SCHEDULE OF CHANGES

72-80+82 LEATHER LANE LONDON, EC1N 7TR

PROPOSED REAR ELEVATION - EAST

A118

PROPOSED EAST ELEVATION
SCALE 1:100@A3

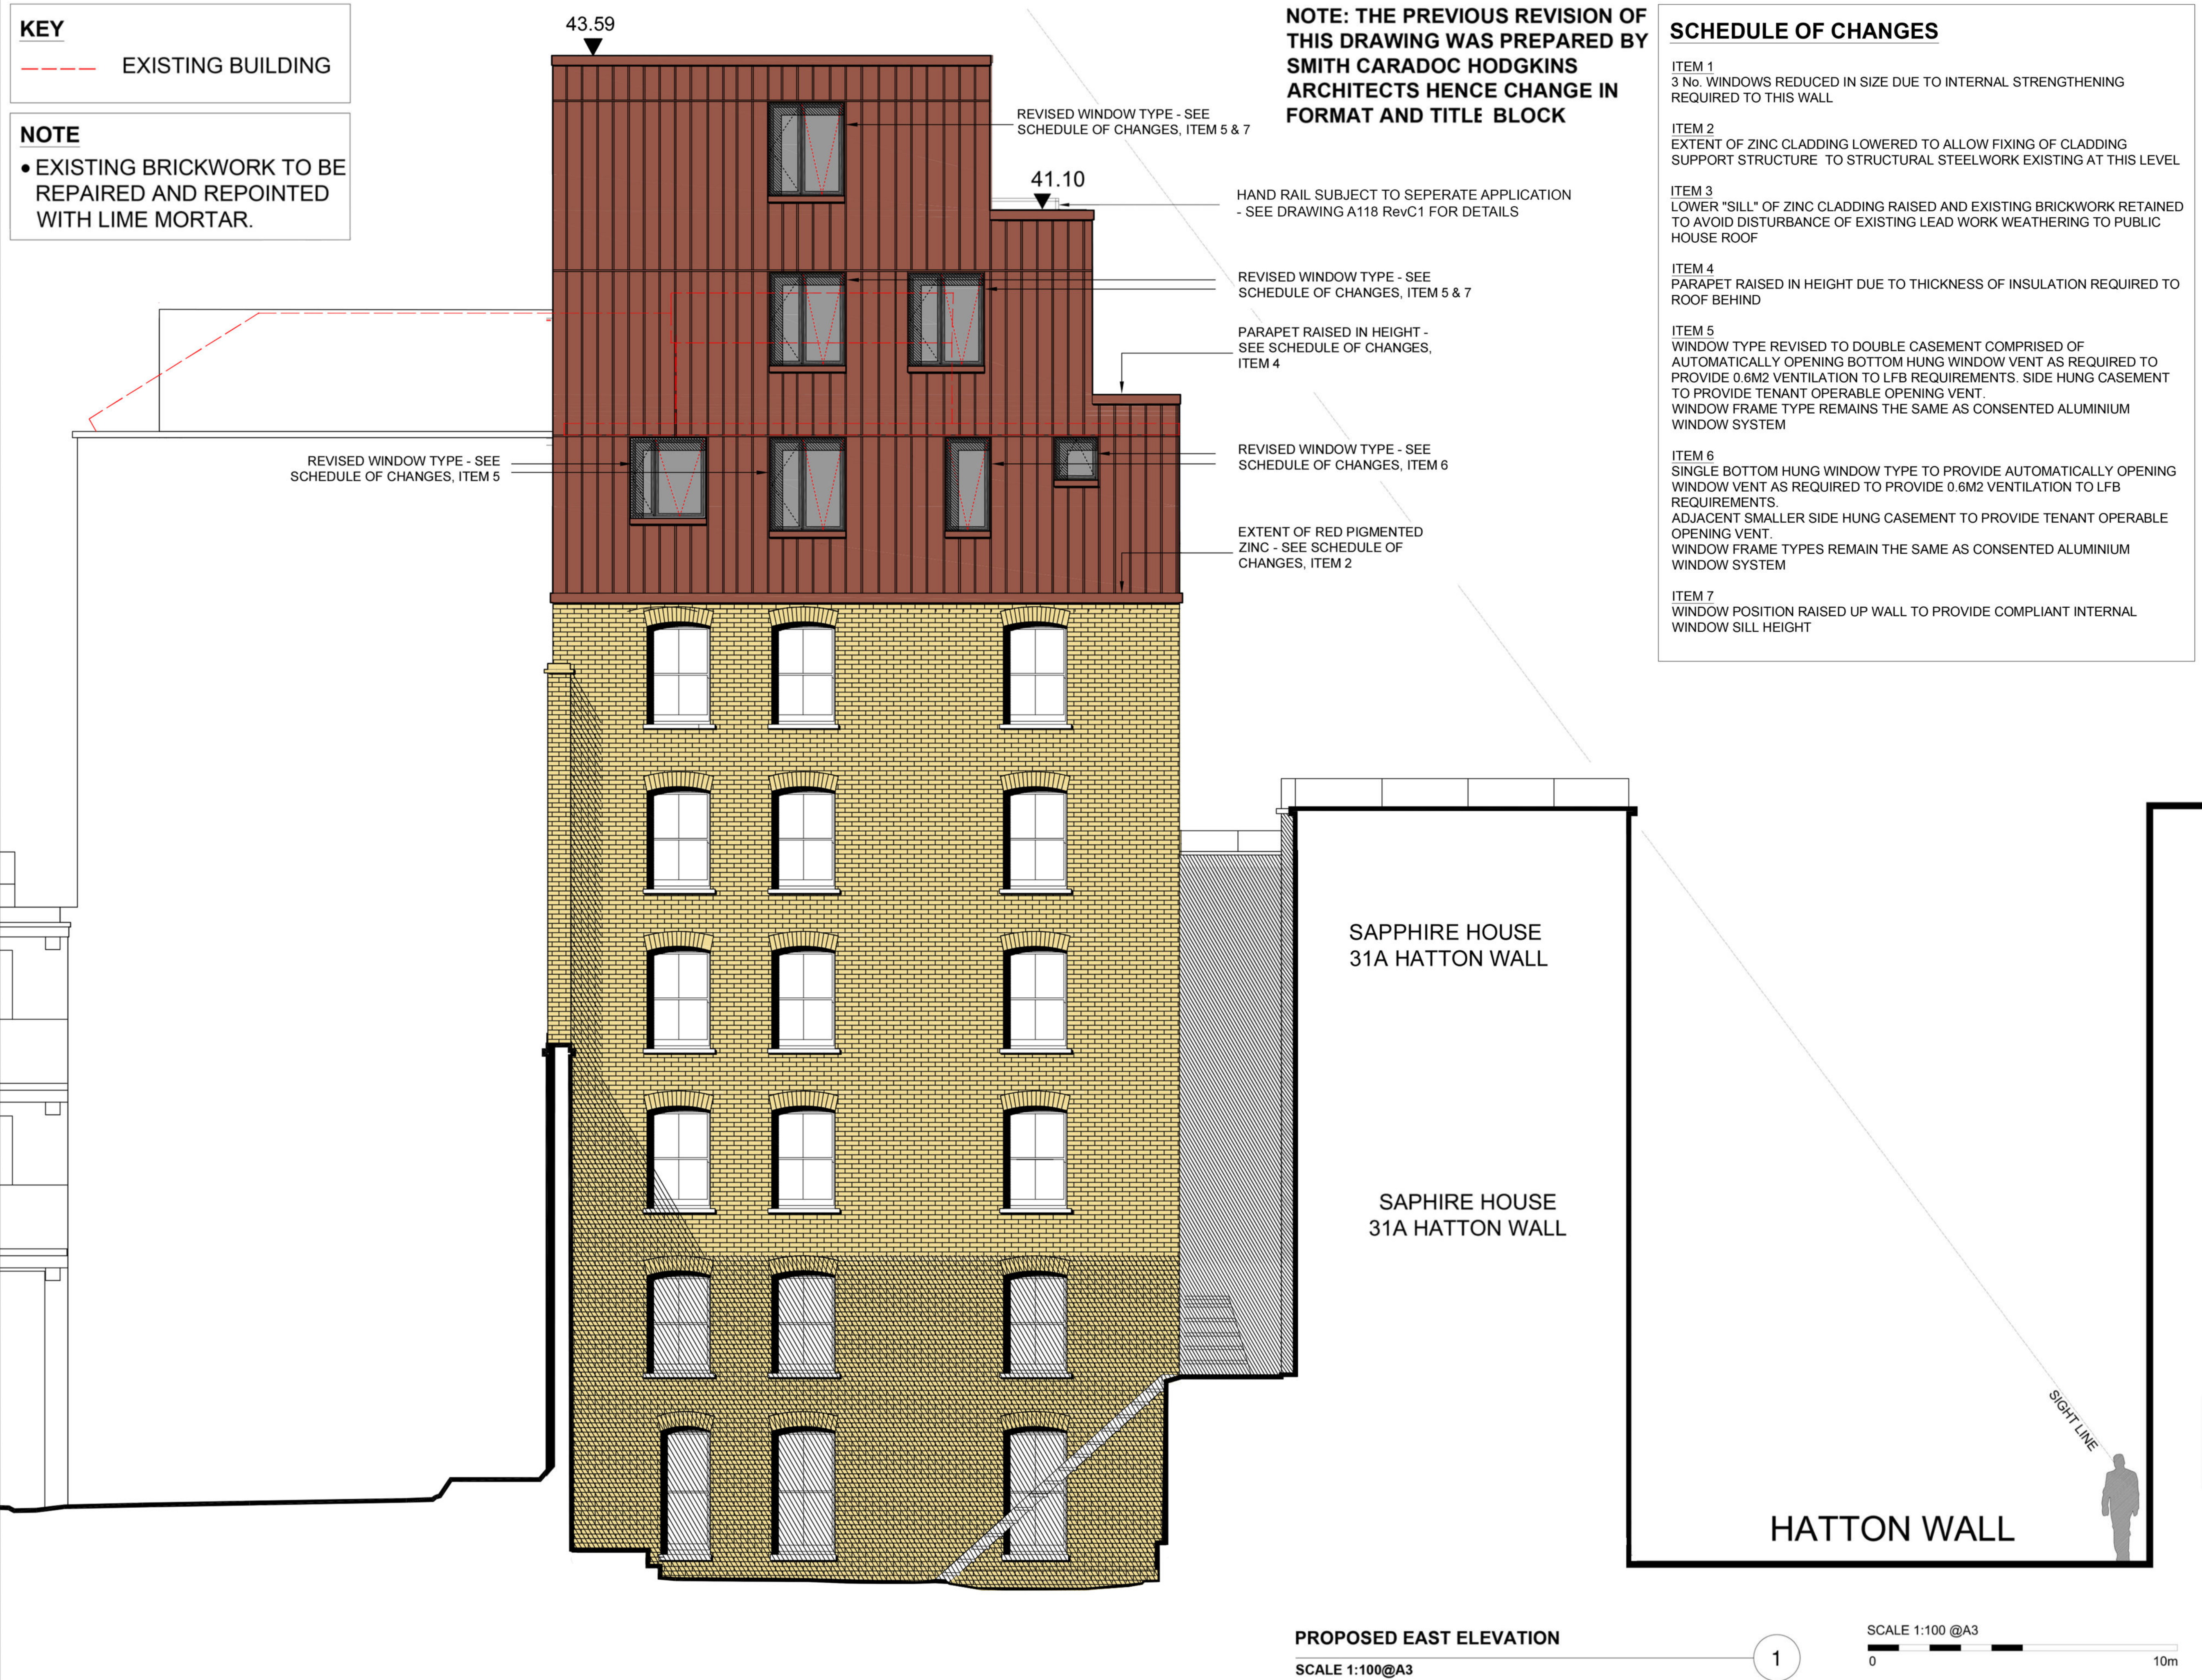
EXISTING BRICKWORK TO BE REPAIRED AND REPOINTED WITH LIME MORTAR.

- ITEM 1
3 No. WINDOWS REDUCED IN SIZE DUE TO INTERNAL STRENGTHENING REQUIRED TO THIS WALL
- ITEM 2
EXTENT OF ZINC CLADDING LOWERED TO ALLOW FIXING OF CLADDING SUPPORT STRUCTURE TO STRUCTURAL STEELWORK EXISTING AT THIS LEVEL

- ITEM 3
LOWER "SILL" OF ZINC CLADDING RAISED AND EXISTING BRICKWORK RETAINED TO AVOID DISTURBANCE OF EXISTING LEAD WORK WEATHERING TO PUBLIC HOUSE ROOF

- ITEM 4
PARAPET RAISED IN HEIGHT DUE TO THICKNESS OF INSULATION REQUIRED TO ROOF BEHIND
- ITEM 5
WINDOW TYPE REVISED TO DOUBLE CASEMENT COMPRISED OF AUTOMATICALLY OPENING BOTTOM HUNG WINDOW VENT AS REQUIRED TO PROVIDE 0.6M2 VENTILATION TO LFB REQUIREMENTS. SIDE HUNG CASEMENT TO PROVIDE TENANT OPERABLE OPENING VENT. WINDOW FRAME TYPE REMAINS THE SAME AS CONSENTED ALUMINIUM WINDOW SYSTEM

- ITEM 6
SINGLE BOTTOM HUNG WINDOW TYPE TO PROVIDE AUTOMATICALLY OPENING WINDOW VENT AS REQUIRED TO PROVIDE 0.6M2 VENTILATION TO LFB REQUIREMENTS. ADJACENT SMALLER SIDE HUNG CASEMENT TO PROVIDE TENANT OPERABLE OPENING VENT. WINDOW FRAME TYPES REMAIN THE SAME AS CONSENTED ALUMINIUM WINDOW SYSTEM

- ITEM 7
WINDOW POSITION RAISED UP WALL TO PROVIDE COMPLIANT INTERNAL WINDOW SILL HEIGHT
